### RE: NEW LIVERPOOL PRIMARY SCHOOL SSD-10391 RESPONSE TO TRANSPORT RELATED SUBMISSIONS

A State Significant Development (SSD) application has been submitted for the New Liverpool Primary School project at 18 Forbes Street, Liverpool. GTA, now Stantec completed a Transport and Accessibility Impact Assessment and Student Transport Plan, both dated 11 June 2021, to support the SSD application.

# ATTACHMENT 1

## Response to Submissions

**SWEPT PATH ASSESSMENT**

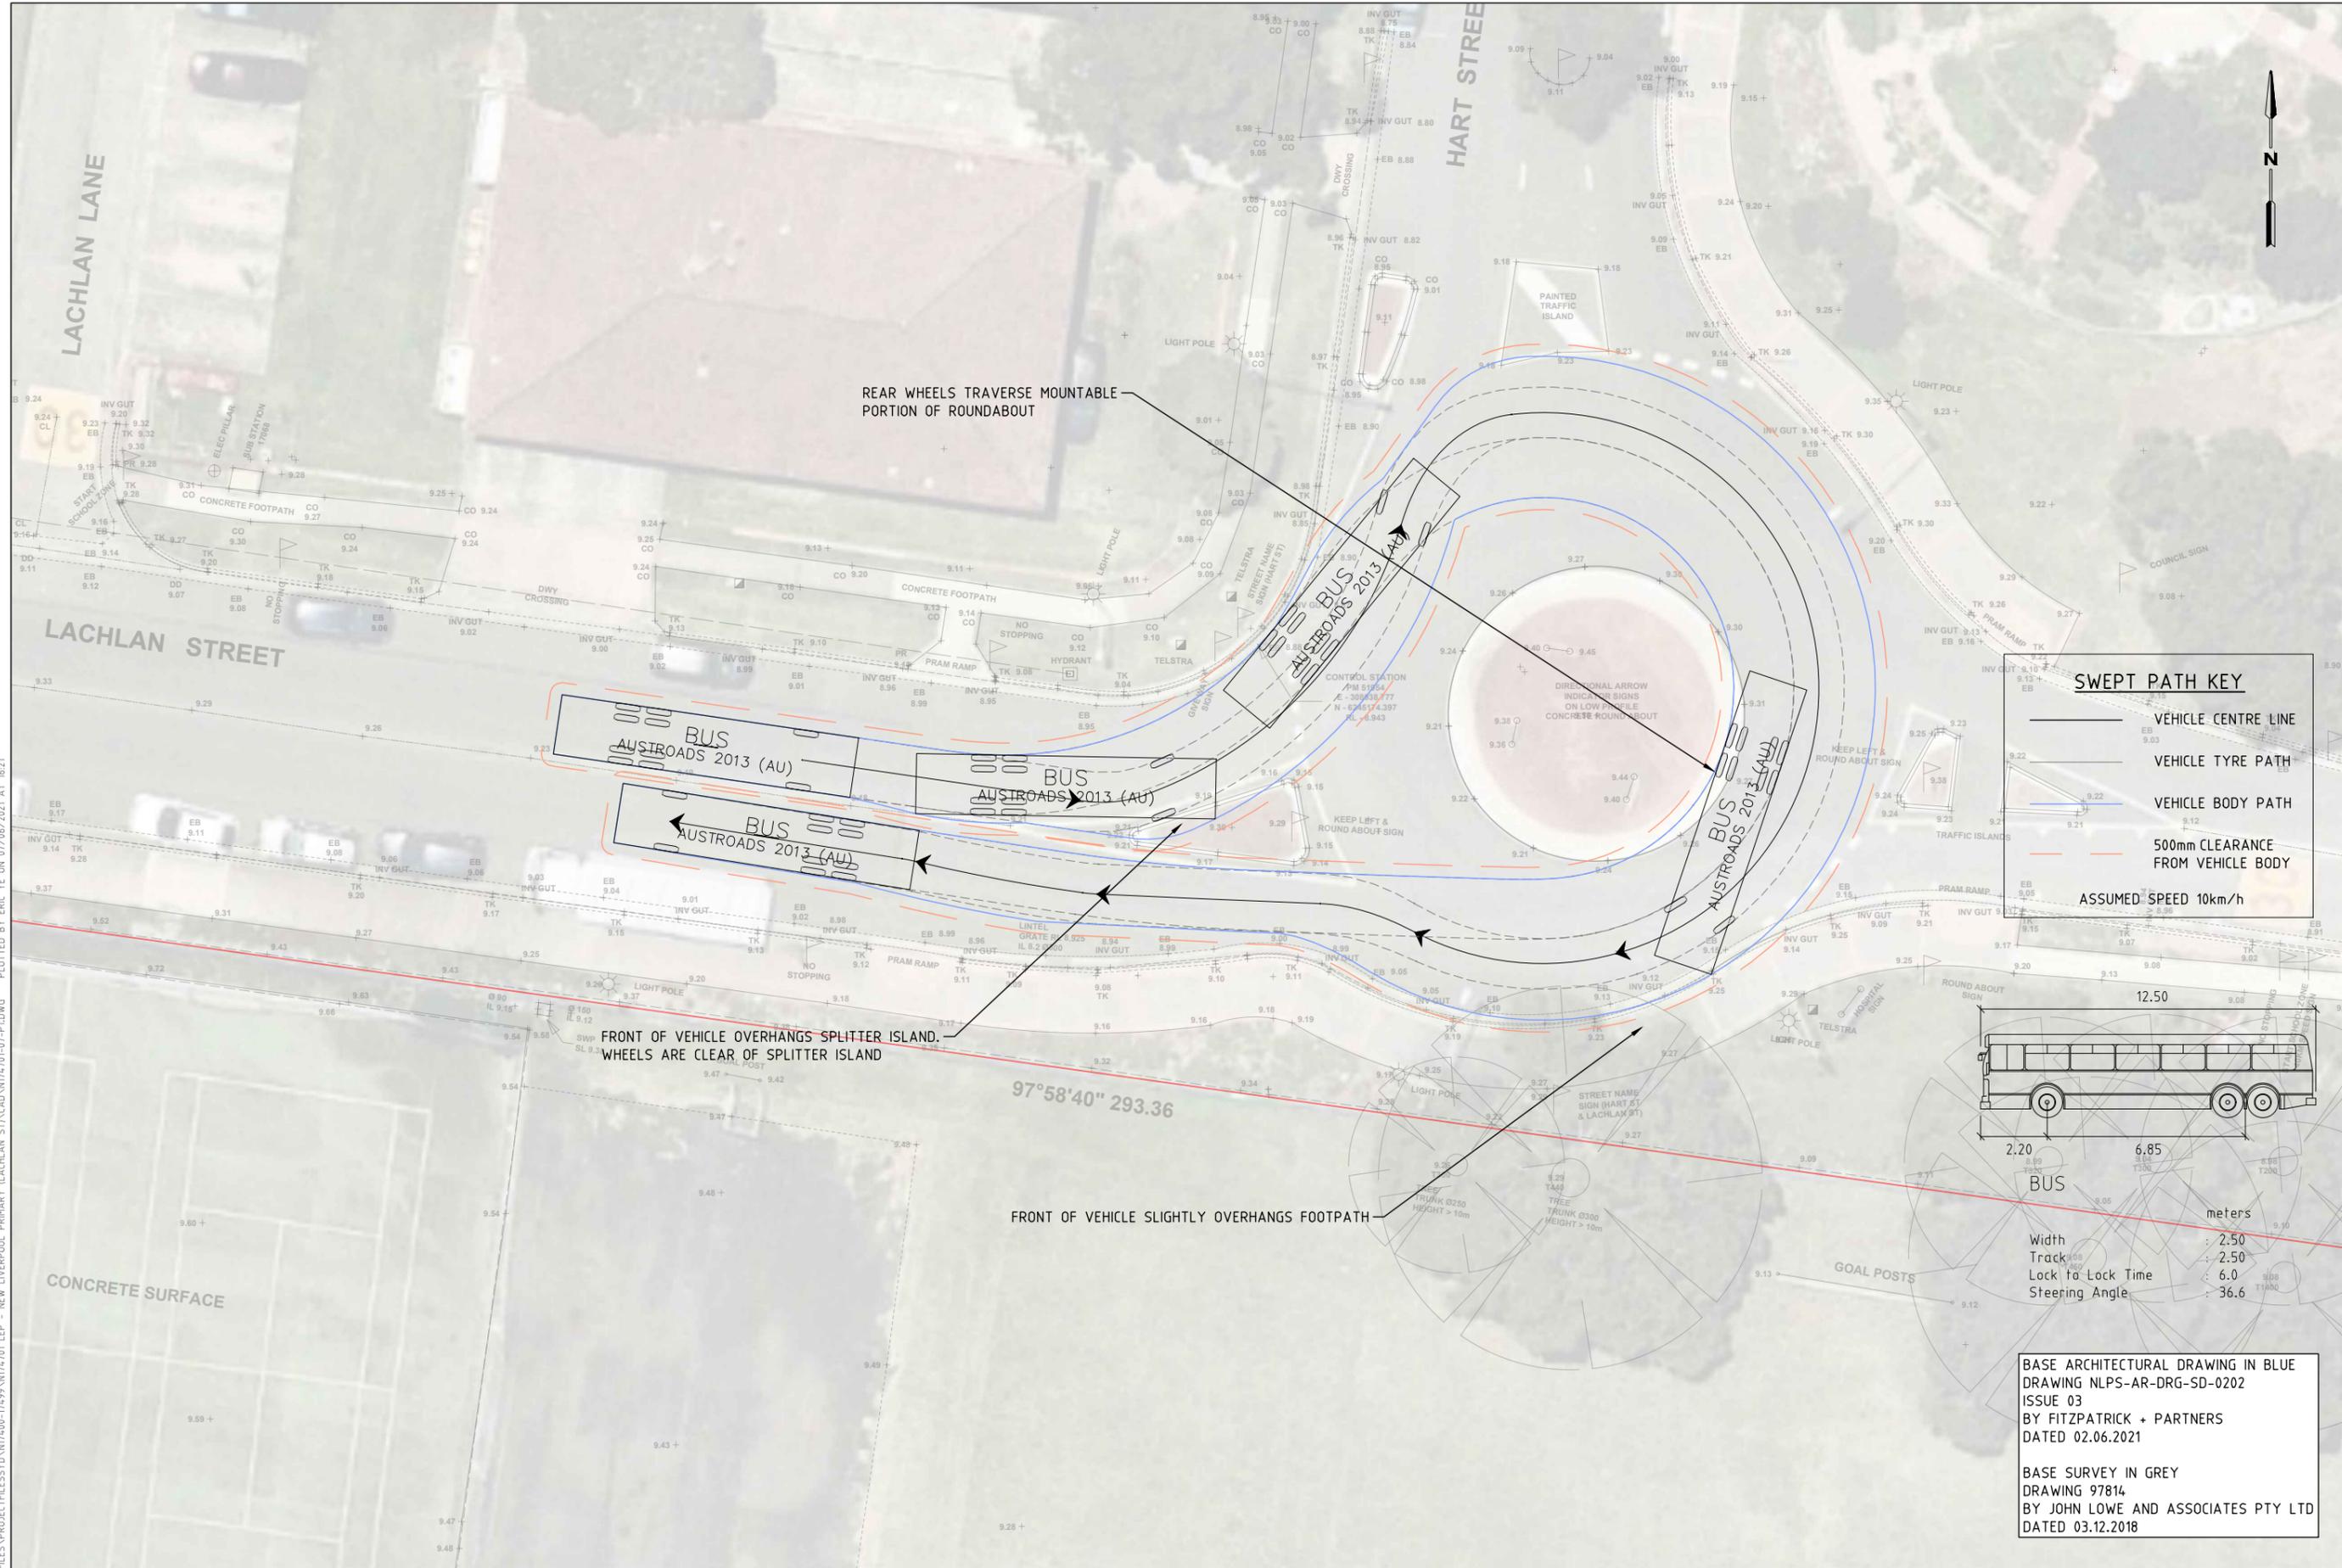
Comment	Responses
<b>Department of Planning, Industry and Environment (DPIE)</b>	
<p>The Waste Hardstand Site Plan (Appendix K) includes details of a medium rigid vehicle (MRV) turning circle, which would access the site for waste collection in the future. However, the Department notes that the allocated hardstand space is not sufficient for MRV manoeuvring and that the MRV would encroach into the bike rack area and the ELC play area.</p> <p>Please address this issue and relocate/resize the hardstand area or relocate the vehicle turning circle area to allow for adequate manoeuvring of MRV within the site.</p>	<p>The hardstand area is part of a separate application that is still processing through detailed design. The design has been modified by the architect and can accommodate waste vehicles turning around on site and therefore can enter and exit the site in a forward direction. Updated swept path review attached.</p>
